7 July 2021

631.30274.00000-L01-v0.6-20210707.docx

**Proposed s4.55(1A) Application for the Modification of Consent SSD 8999 for Minor Design Changes and to Amend Conditions of Consent
35 Honeysuckle Drive, Newcastle NSW 2300**

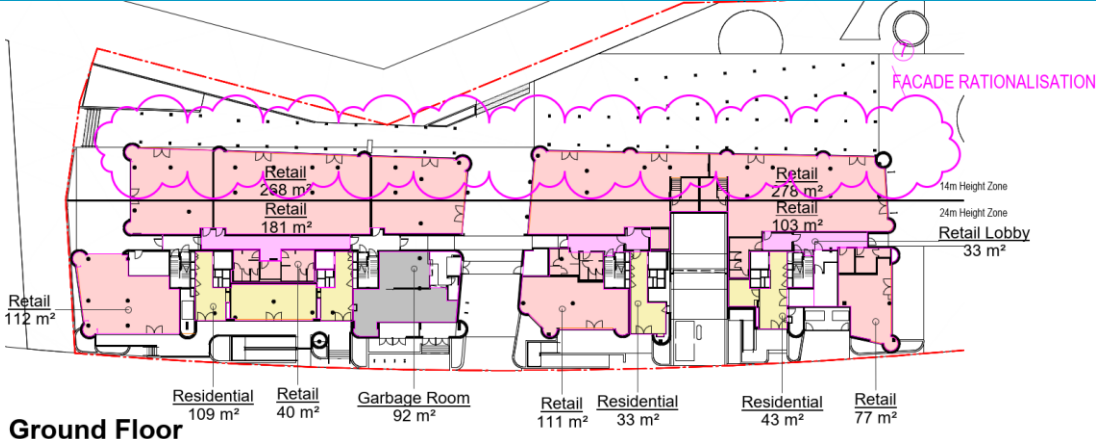
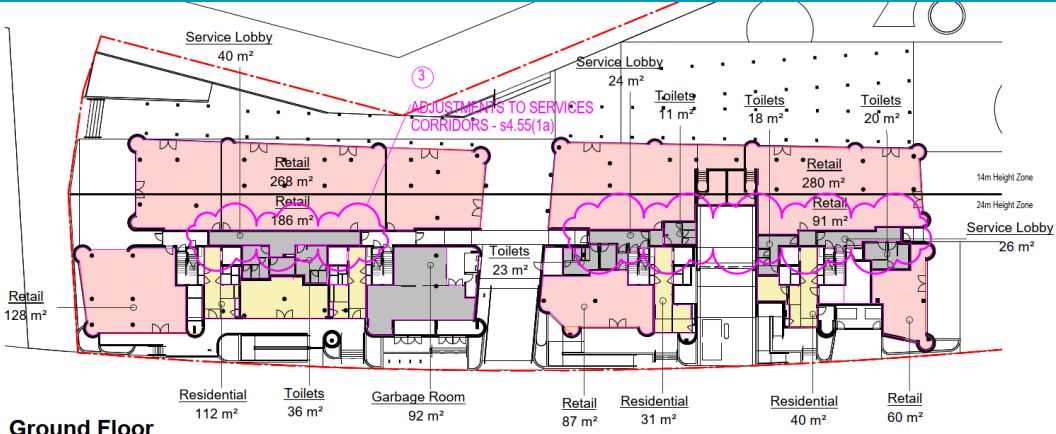
- 2. An assessment of the visual impacts of the proposed pergolas and changes to plant.*

Response: The pergolas are proposed on 2 units on the top level, they do not increase the overall height of the building or extent past the building envelope. An extract in Table 2 below demonstrates the current consent under Mod 4 compared to the proposed amendments and includes the added pergolas and smaller plant, from the most obvious elevations. Further elevations and through site elevations are provided in the plans at Appendix A.

The images demonstrate that the amended plant and pergola additions do not increase bulk and scale, and will not impact on any surrounding views.
